**UNITED STATES OF AMERICA
NUCLEAR REGULATORY COMMISSION
BEFORE THE ATOMIC SAFETY AND LICENSING BOARD**

In the Matter of)
Tennessee Valley Authority) Docket No. 52-047-ESP
(Clinch River Nuclear Site))

**INTERVENORS' MOTION FOR LEAVE TO FILE
CONTENTION 4 (INADEQUATE DISCUSSION OF
ENVIRONMENTAL IMPACTS OF SPENT FUEL POOL FIRES)
AND CONTENTION 5 (IMPERMISSIBLE DISCUSSION OF ENERGY
ALTERNATIVES AND NEED FOR THE PROPOSED SMR)**

Figure 1A-1 Heatup time from 30 °C to 900 °C

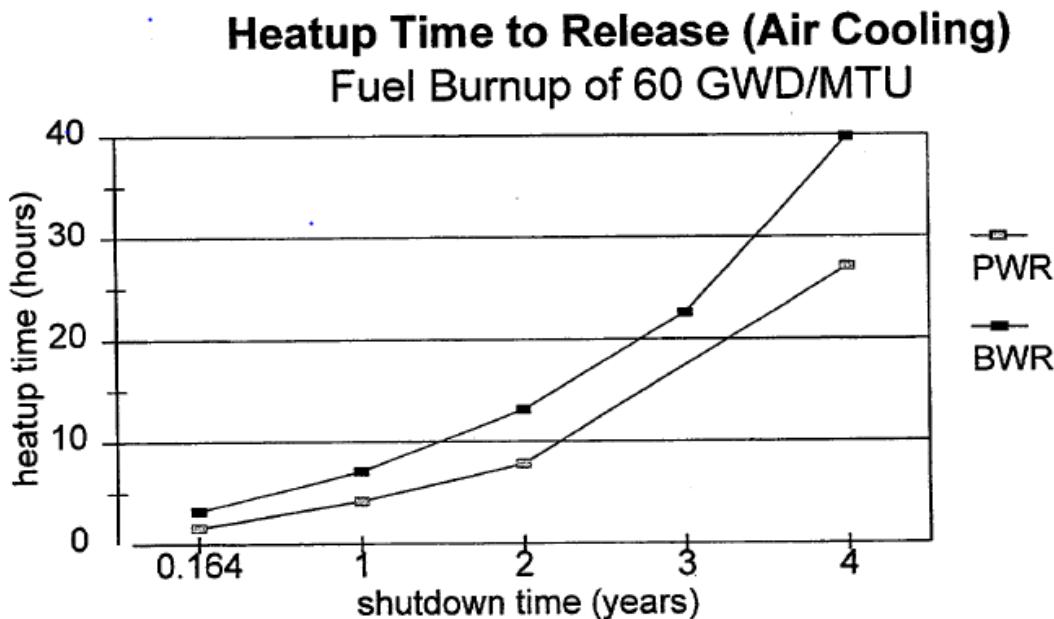
First, the Draft EIS completely neglects a significant factor in pool fire risks: the different length of the average decay time of the spent fuel inventory in the NuScale SMR pool as compared to a LWR. Decay time is an important factor in spent fuel pool fire risk analysis because "[t]he only significant heat source initially would be the decay heat." NUREG-1738 at A1A-2. As shown in Figure 1A-1 of NUREG-1738, decay heat, which decreases with time after fuel is discharged to the pool, is a key factor in determining how long it would take for a pool fire to start:

Figure 1A-1 shows that for the configuration modeled, and for decay times of less than about 2 years for PWRs and 1.5 years for BWRs (assuming burnup of 60 GWD/MTU), it would take less than 10 hours for a zirconium fire to start or for significant fission product releases to begin once the fuel was fully uncovered and the fuel was cooled by an air flow of about two building volumes per hour. The figure also shows that after 4 years, PWR fuel could reach the point of fission product release in about 24 hours.

Id. at A1A-4. Similarly, the 2014 Spent Fuel Pool Study found that spent fuel is only susceptible to a radiological release within a few months after the fuel is moved from the reactor to the spent fuel pool.” *Id.* at iii-iv. Thus, the amount of time that has passed after discharge of fuel to the pool is a significant factor in the speed at which uncovered spent fuel will ignite.

In addition to affecting the speed at which an accident occurs, decay time also affects the number of early fatalities that may occur in a spent fuel pool accident. As stated in NUREG-1738, “[a]pproximately 85 percent of all the ruthenium in the pool is in the last core off-loaded since the ruthenium-106 half-life is about 1 year.” NUREG-1738, Figure 3.7-1 and Figure ES-1,

The Staff bases its environmental analysis on the assumption that TVA will refuel each SMR at a frequency of two years. Draft EIS at 5-86. Two years is also the refueling cycle for the reference LWR studied in the Spent Fuel Pool Study. *Id.* at D-32. But the NuScale design – which the NRC Staff claims is encompassed by the Draft EIS’ environmental analysis -- is distinctly different from the reference LWR with respect to its reactor design and refueling pattern. While the reference LWR in the Spent Fuel Study was assumed to discharge 296 fuel assemblies to a pool of 30,055 assemblies every two years, the NuScale design calls for twelve separate reactors that would discharge fuel to a single pool. Although each reactor will be on a two-year refueling schedule, refueling of all twelve reactors will be “staggered,” *i.e.*, fuel will be discharged to the fuel every two months rather than every two years.¹ In contrast to an LWR pool, in which the hottest fuel is present only once every two years, the hottest fuel will be added to the SMR pool every two months. This pool loading pattern will result in different probabilities of zirconium fire ignition over an operating cycle than those used in NUREG-2161 and other past NRC studies to estimate public health and environmental impacts of pool fires at large LWRs. The Draft EIS completely fails to address the risk implications of this significant design difference from the large LWRs analyzed in previous NRC studies.
